2.8 Individual Responses to Comments from Municipalities

2.8.1 Brisbane Parks and Recreation Commission

2.8.2 City of Daly City

2.8.3 City and County of San Francisco

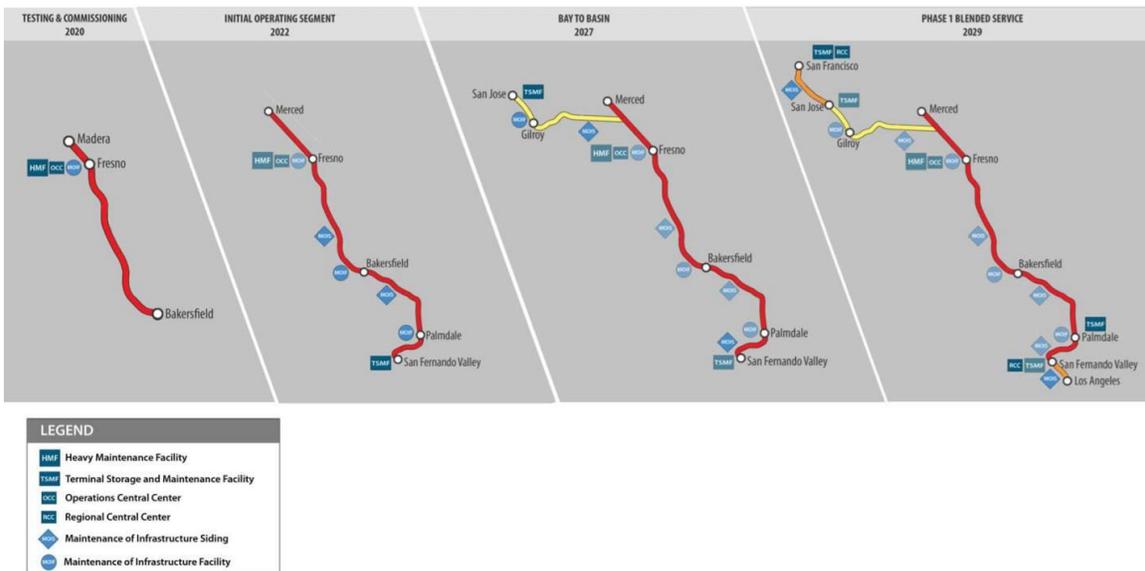
The Authority’s 2012 NOP response letter states that the Authority is “currently re-examining the corridor to identify site specific and operationally feasible locations which will meet maintenance and storage requirements. Suitable potential sites, in addition to Brisbane, will be evaluated through the NEPA and CEQA environmental processes.” The document cited in Comment SFOM-4, *Summary of Requirements for O&M Facilities* (April 30, 2013), states, “It should be noted that the siting of the O&M facilities has not been determined at this time. For illustrative purposes only, hypothetical locations of each facility are shown in Figure 1 and Table 1 for the progression of the phased development of the Project.” Thus, it is clear that the Authority does not have a recommended location for the high-speed rail maintenance yard, as Comments SFOM-4 and SFOM-7 appear to assert.

Table 1 of the high-speed rail O&M needs analysis is labeled “Summary of O&M Facilities (For Illustrative Purposes Only),” and identifies the need for an approximate 100-acre site at a San Francisco location. Neither Brisbane nor the Baylands are mentioned in Summary of Requirements document. Figure 1 from the 2013 *Summary of Requirements for O&M Facilities* is included below. As shown, neither Brisbane nor the Baylands are identified in that figure.
